City of West Linn
PRE-APPLICATION CONFERENCE MEETING
Notes
June 6, 2013

SUBJECT: Conditional Use Permit, Class I Design Review, and Non-Conforming approval for permanent community center use at Robinwood Station, 3706 Cedaroak Drive

**Figure 8-4
NEIGHBORHOOD ROUTE
STREET CROSS SECTIONS**

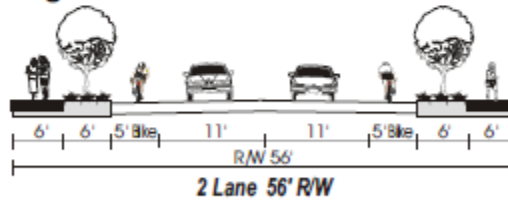
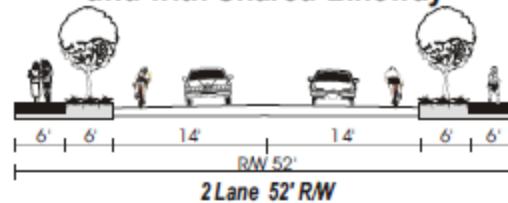
CEDAROAK DRIVE

EXISTING CONDITIONS	POTENTIAL POST DEVELOPMENT CONDITIONS
Classification	Neighborhood	Neighborhood
Right of Way Width	50'	52' Min.
Full Pavement Width	28'	28' Min.
Bike Lane	Fog Line with space for Bike without pavement marking symbol.	Combination width for travel lane and bike lane is 14' min.
Curb and Gutter	None – Along the frontage	Curb and Gutter
Planter Strip	Undefined	5.5'
Sidewalk	None	6'
Street Light	None	New street lights if Street Improvement required.
Utility Pole	Yes	New services to be placed underground
Street Tree	None	Yes
ADA Ramps	None	None
Post Speed	25 MPH	25 MPH
Stripe	Double Center Line and Fog Line	Restriping

**Figure 8-5
RESIDENTIAL LOCAL
STREET CROSS SECTIONS**

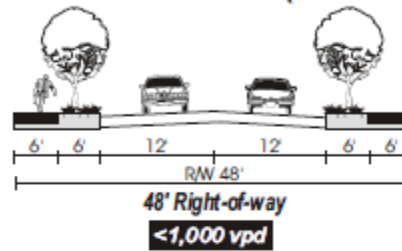
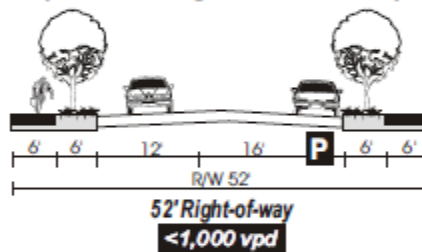
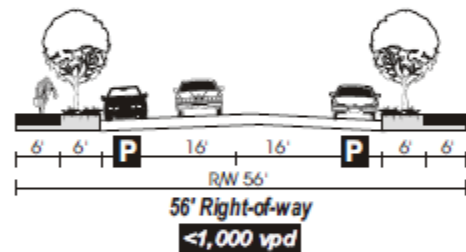
KENTHORPE WAY

EXISTING CONDITIONS	POTENTIAL POST DEVELOPMENT CONDITIONS
Classification	Local	Local
Right of Way Width	50'	48' Min.
Full Pavement Width	18'	24' Min.
Bike Lane	None	None shows on any of the street cross sections in the TSP.
Curb and Gutter	None – Along the frontage	Curb and Gutter
Planter Strip	Undefined	5.5'
Sidewalk	None	6'
Street Light	None	Yes
Utility Pole	None	New services to be placed underground.
Street Tree	Yes – Along the frontage	Yes
ADA Ramps	None	None
Post Speed	25 MPH	25 MPH
Stripe	None	None
